WATER PERMIT NO. 2126-2

WATER PERMIT APPLICATION NO. 2126-2 WARD DAM PROJECT

REVISED REPORT
ON APPLICATION NO. 2126-2
U. S. FOREST SERVICE
July 16, 1990

SD-091-01
WARD DAM
SITE PLAN, MARSH DATA, PROFILES

TRASHRACK, CL PROFILE
NTS

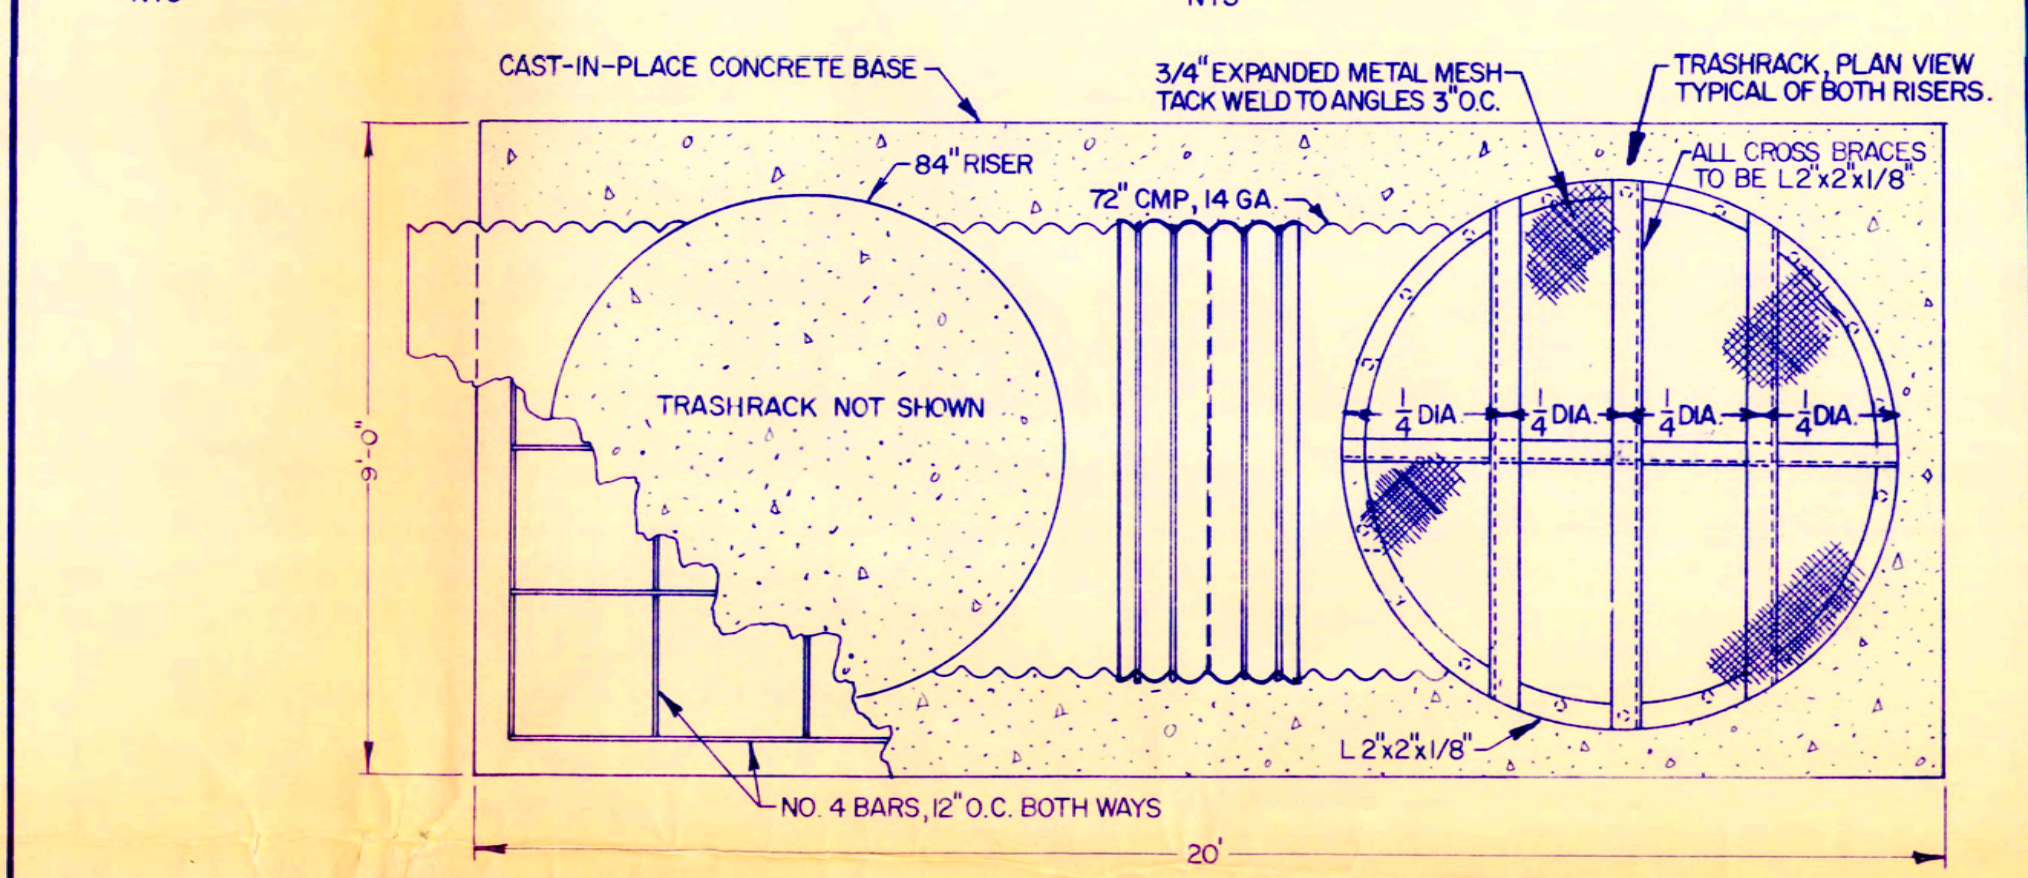
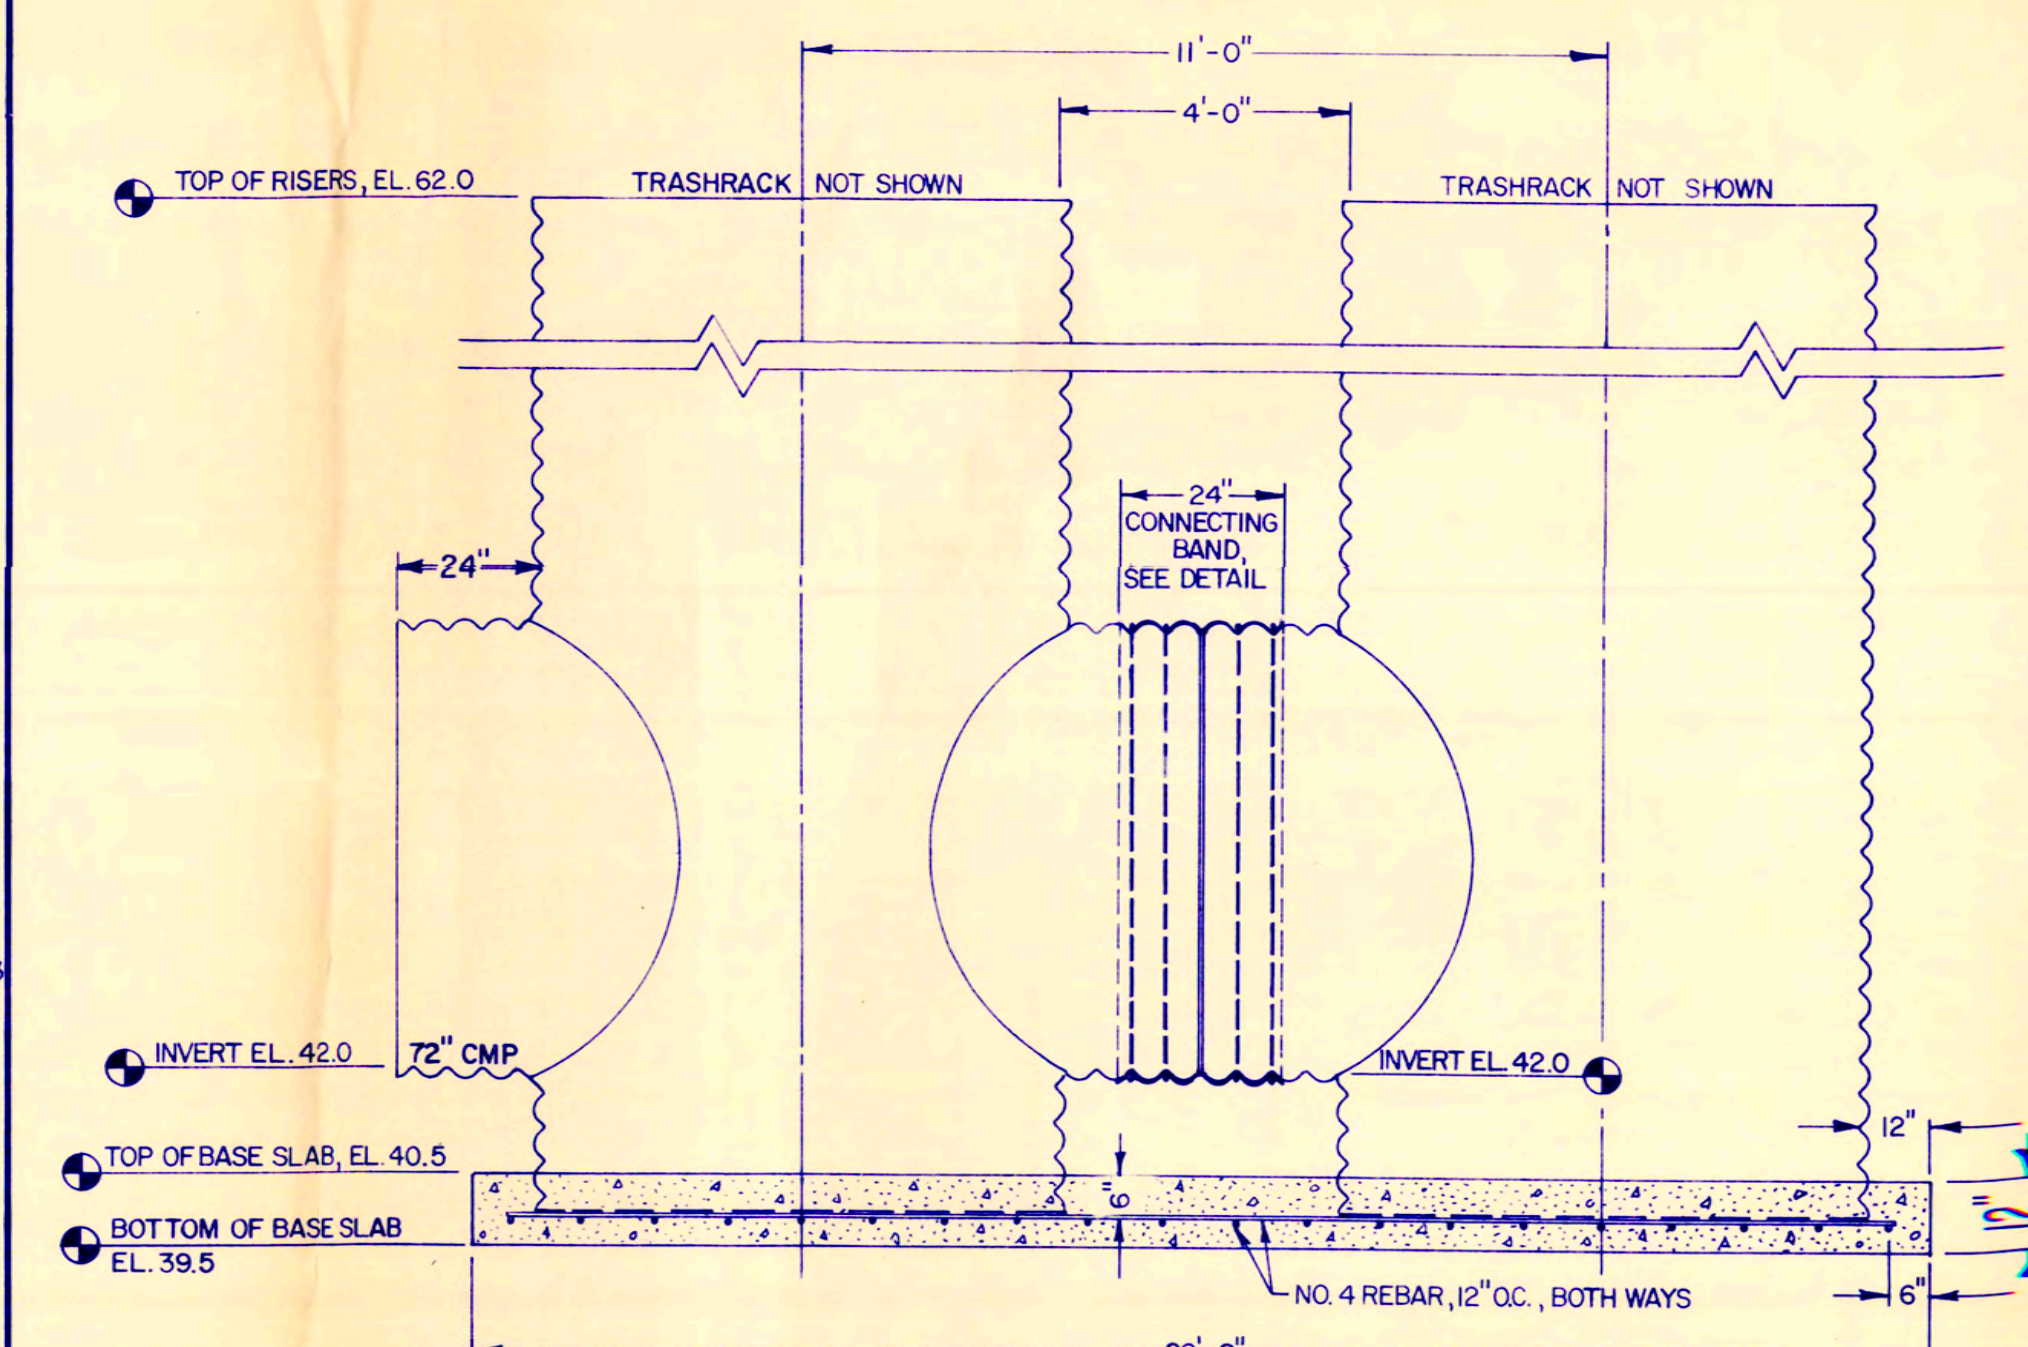
We have reviewed the revised plans for the Ward Dam Project in Pennington County, South Dakota. These plans include the installation of a 6 inch gated conduit at elevation 2956.0 to serve as the structure's low level outlet. The plans as submitted are approved.
